**MONTGOMERY COUNTY HISTORIC PRESERVATION COMMISSION**  
**STAFF REPORT**

<b>Address:</b>	11650 Snowden Farm Pkwy., Germantown Formerly 22022 Ridge Rd.	<b>Meeting Date:</b>	9/3/2025
<b>Resource:</b>	Master Plan Site #13/19 <i>Howes Farm</i>	<b>Report Date:</b>	8/27/2025
<b>Applicant:</b>	NECC	<b>Public Notice:</b>	8/20/2025
<b>Review:</b>	HAWP	<b>Tax Credit:</b>	n/a
<b>Permit Number:</b>	1109684	<b>Staff:</b>	Dan Bruechert
<b>Proposal:</b>	Demolition and reconstruction of barn/accessory building

# Responses to HPC Comments/Recommendations during the consultation meeting held July 9, 2025

EXISTING MAIN FLOOR PLAN.  
TOP ROOF PLAN. ELEVATIONS.  
TO DEMOLISH

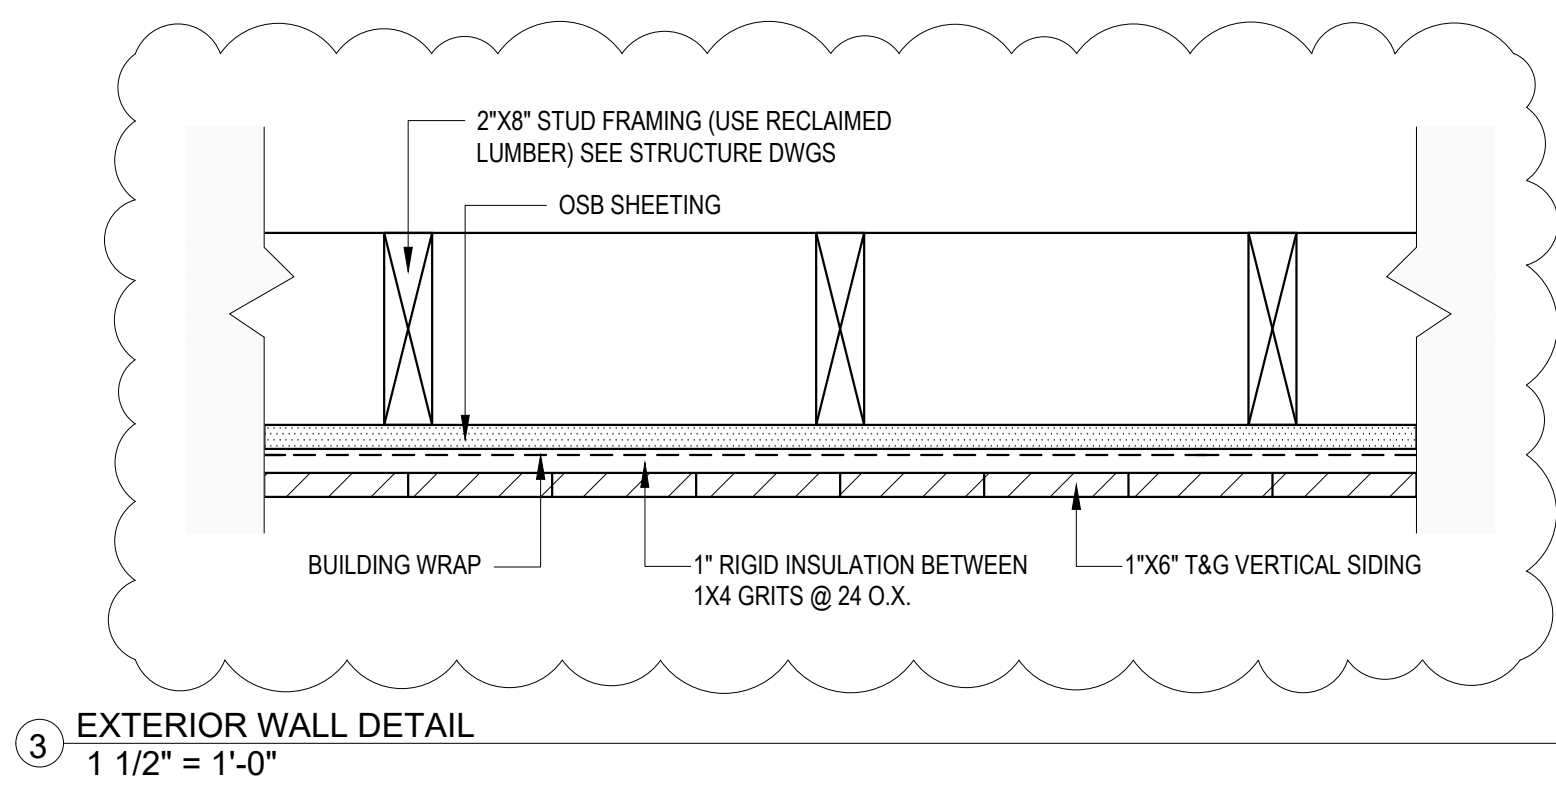
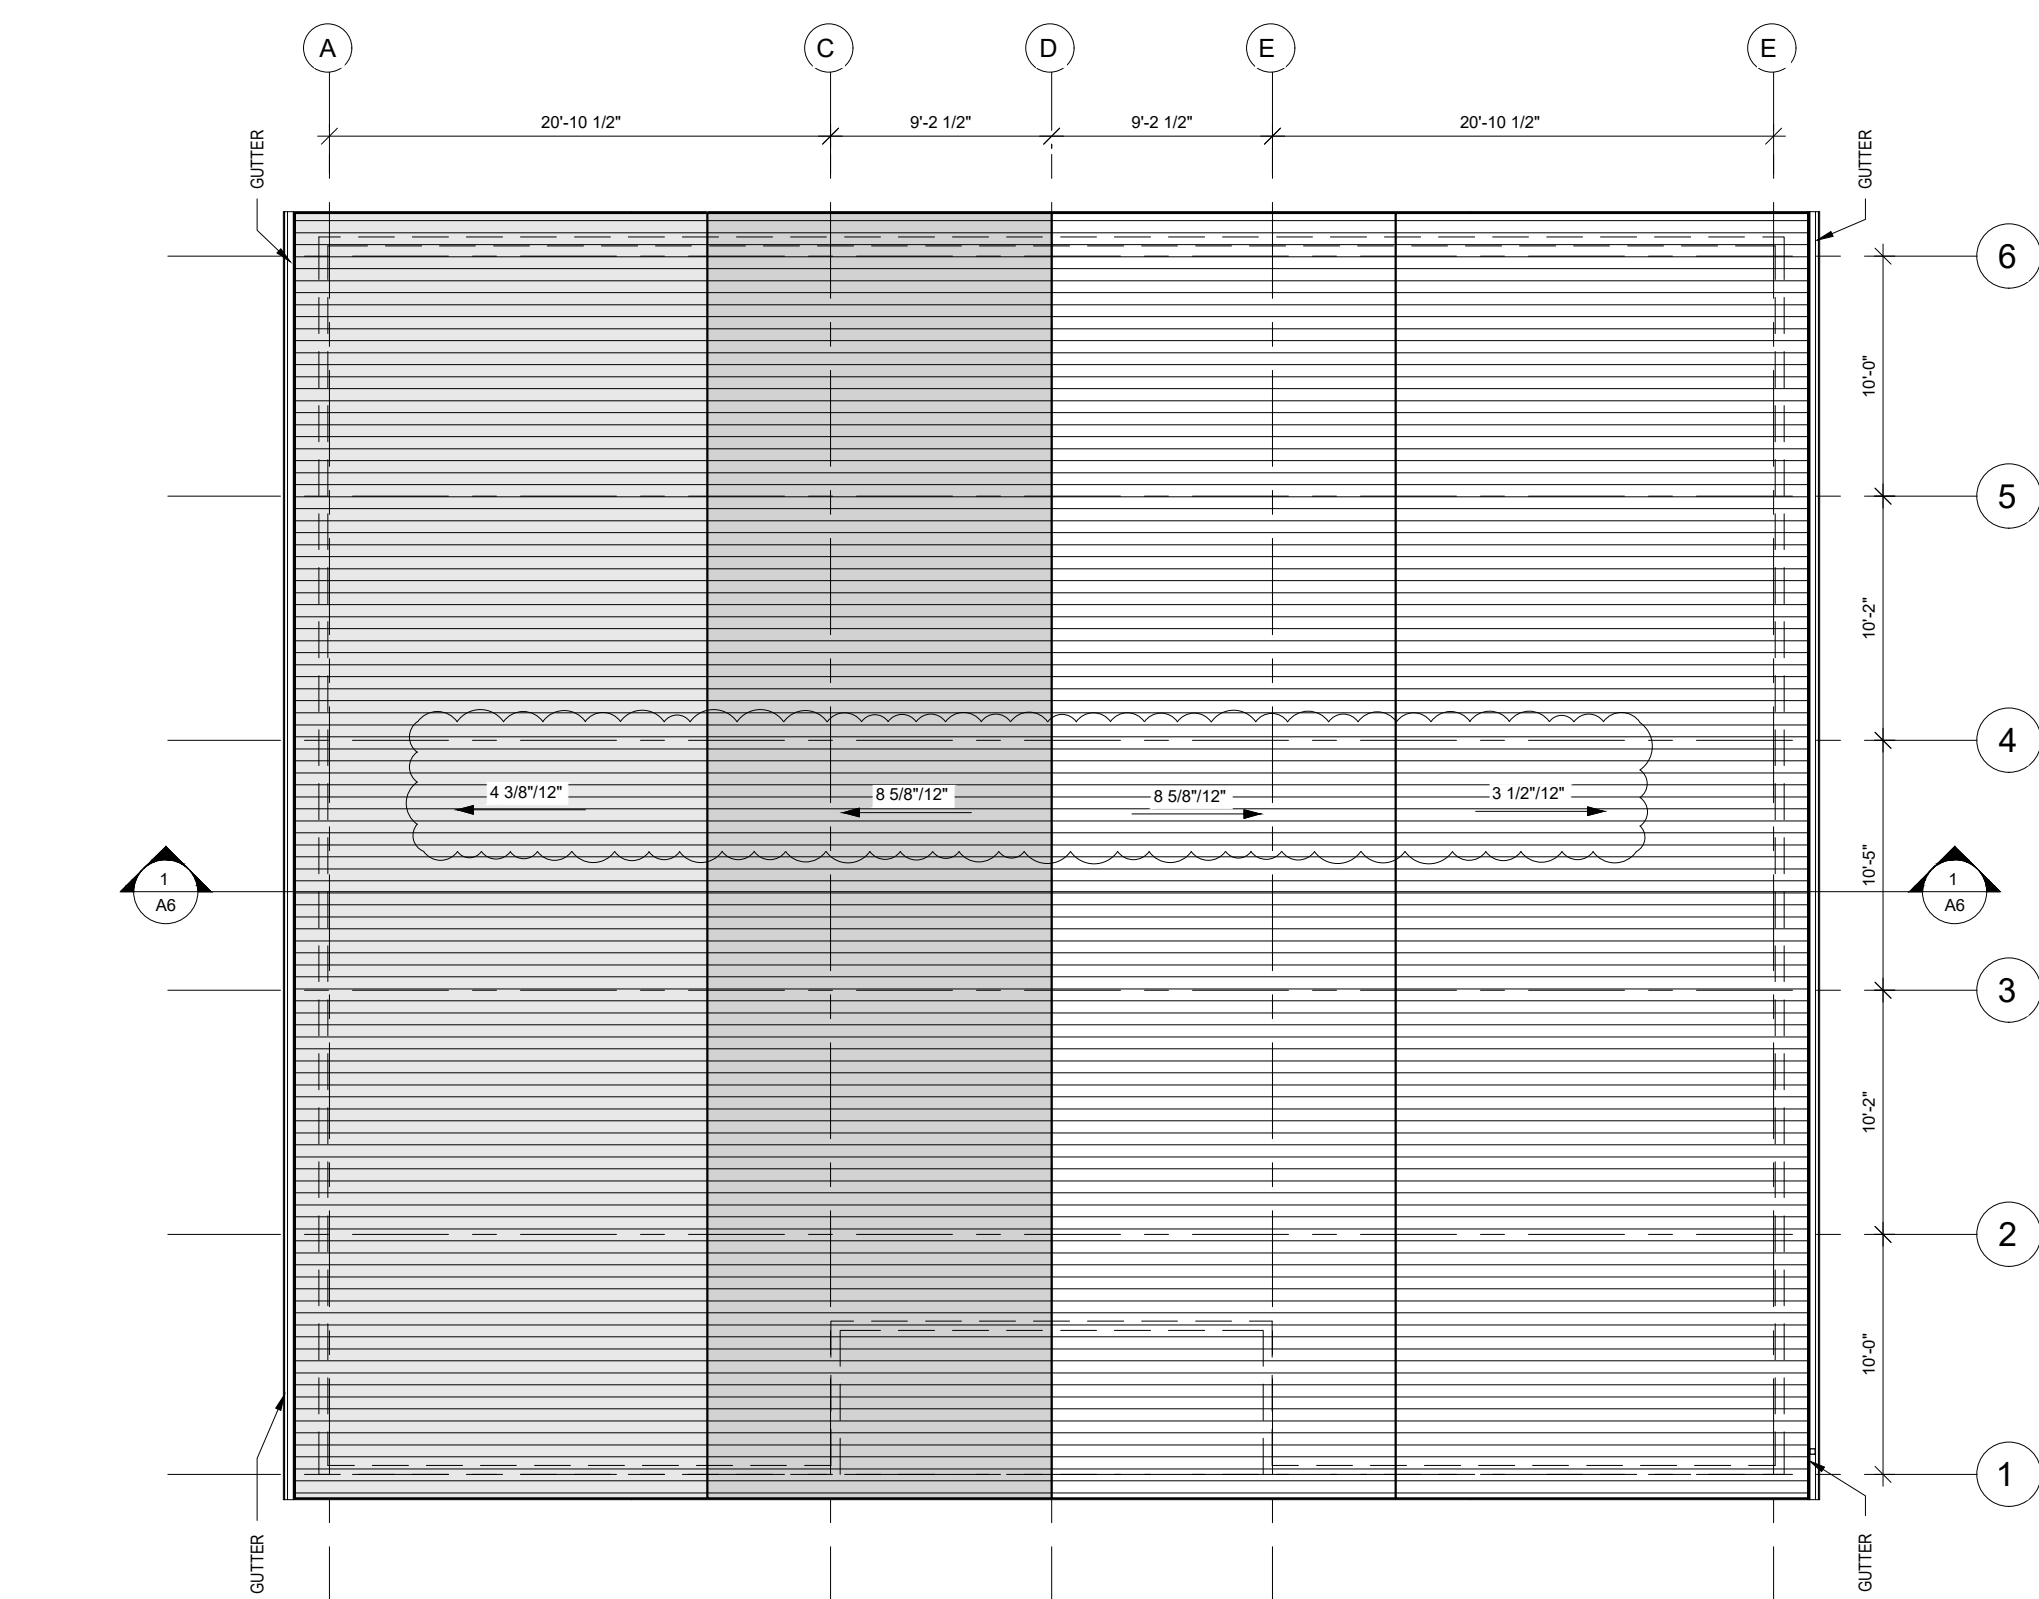
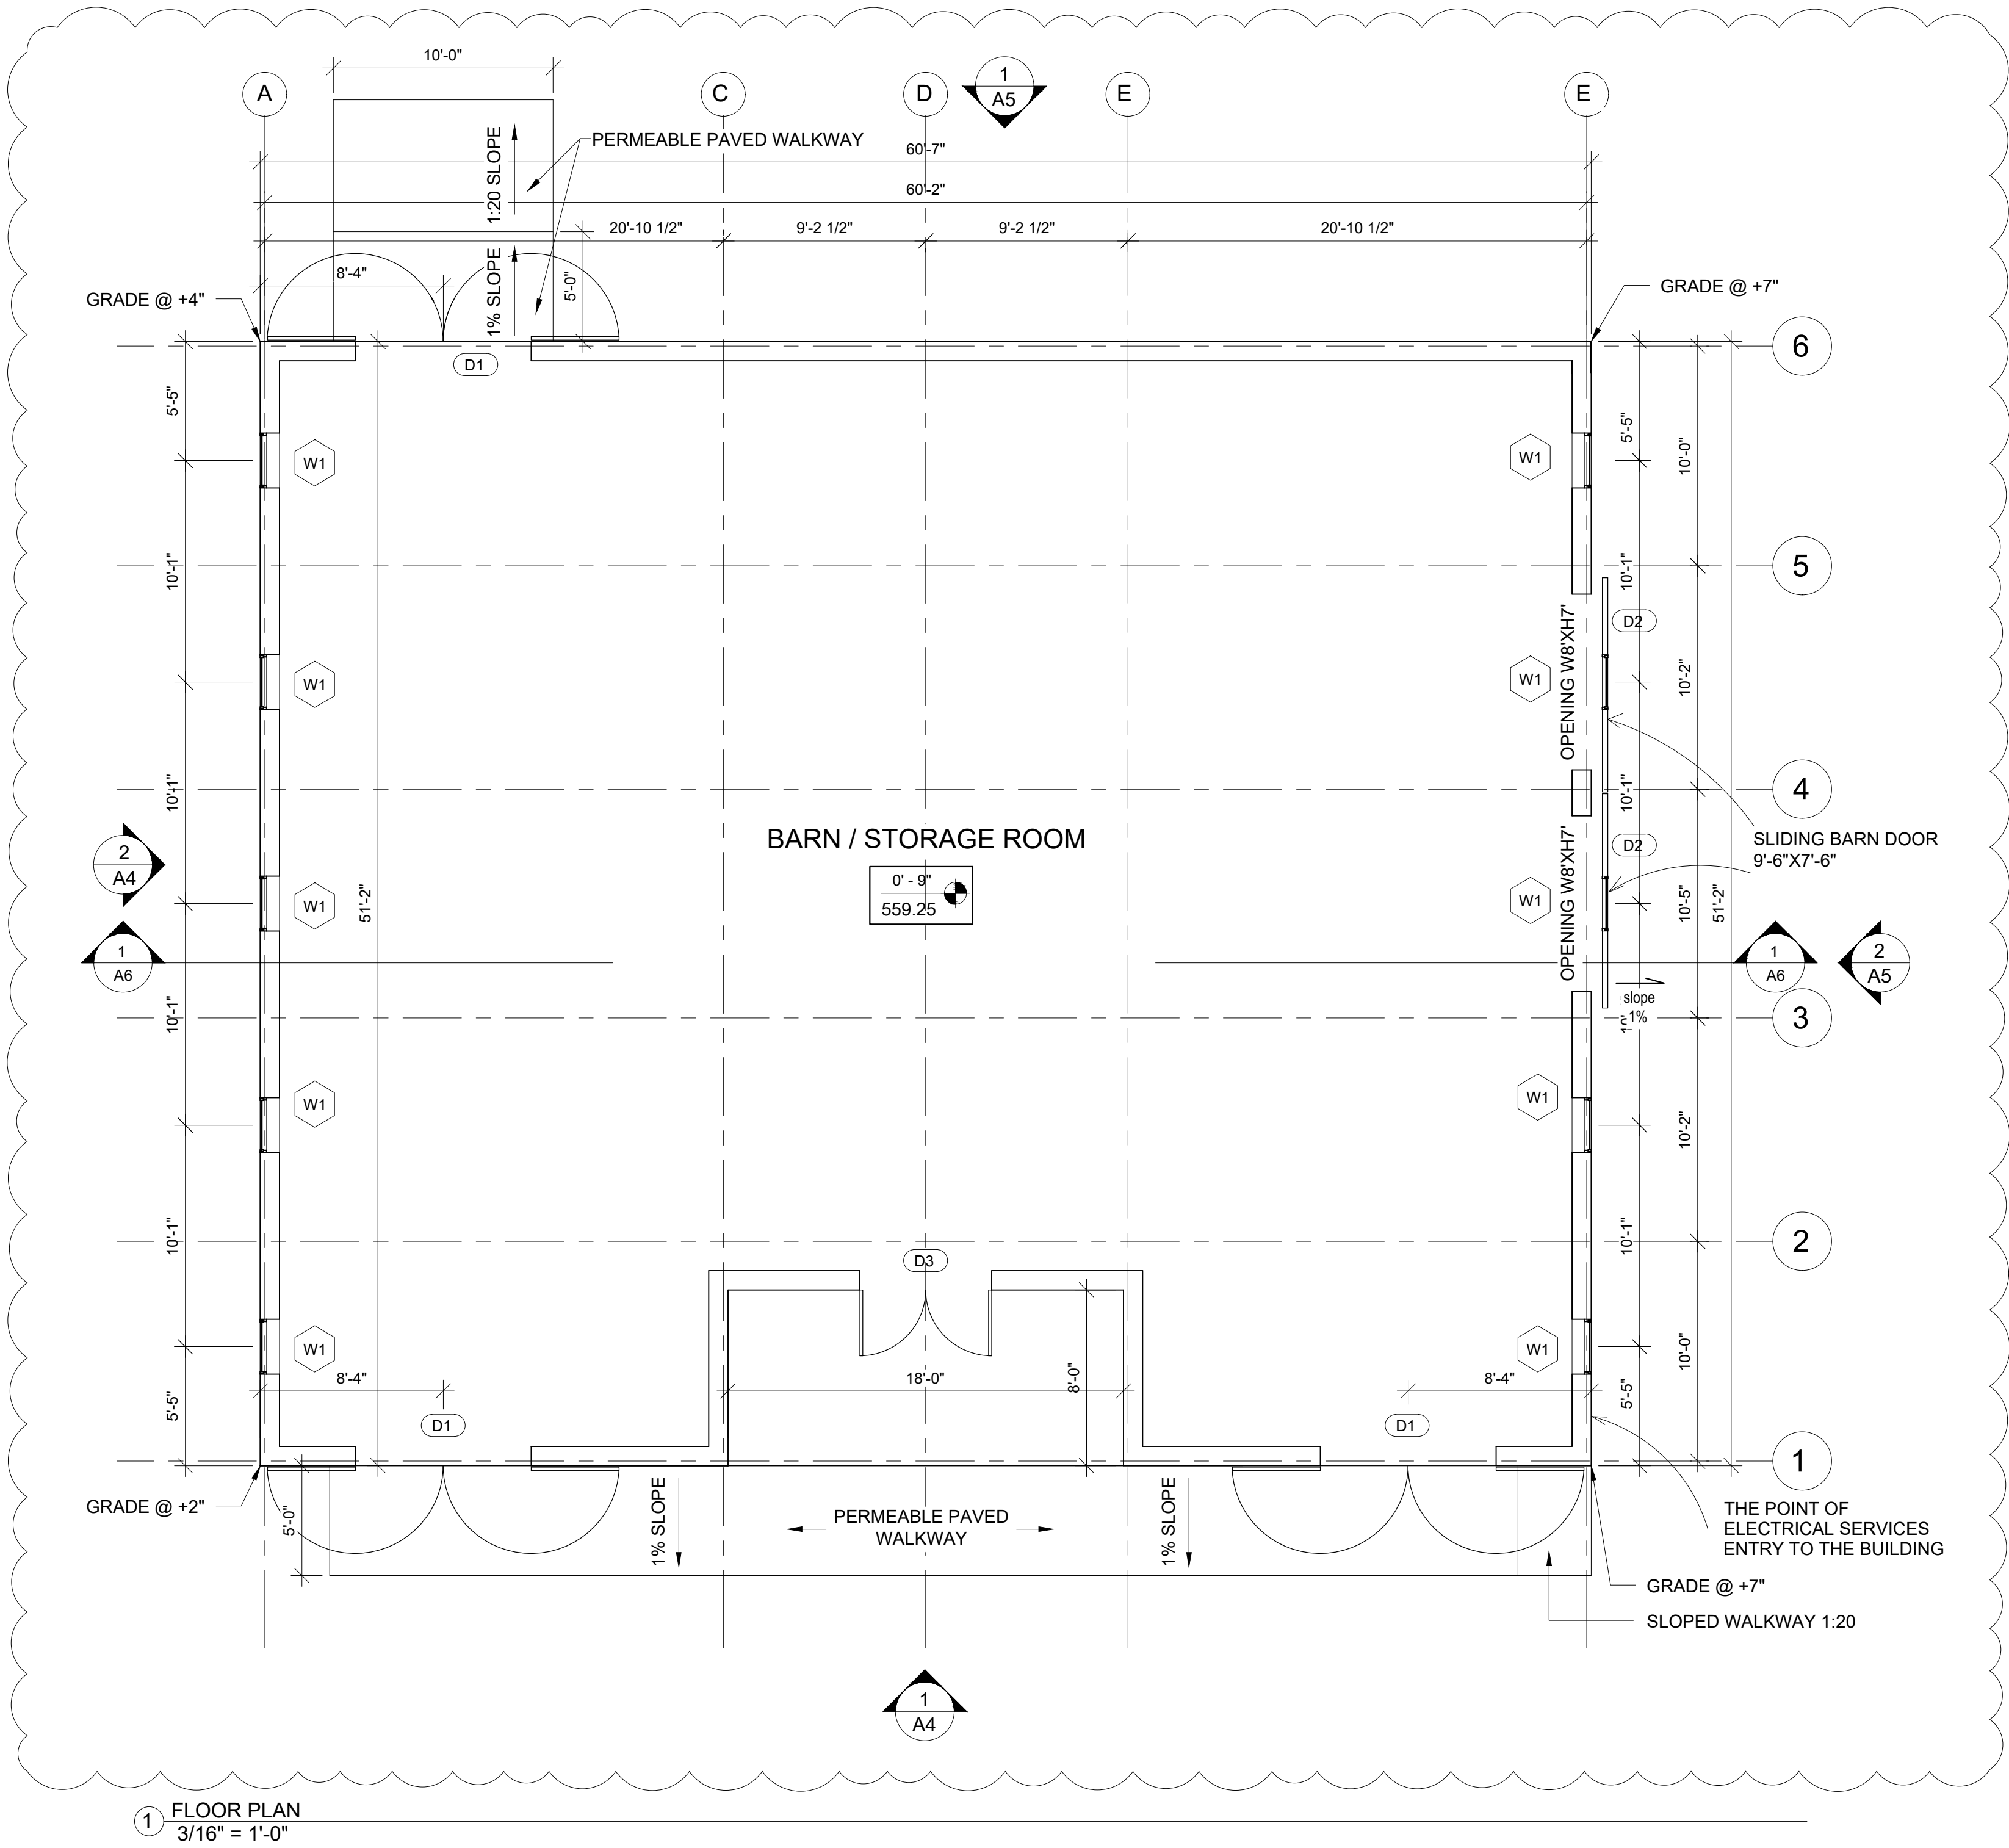
## HPC Comment 2: Roof Slope

NECC: We have made revisions to the drawings to match the existing roof slope. Please refer to drawing sheets A2 for demolition drawing, and A4 and A5 for new elevations and cross sections.
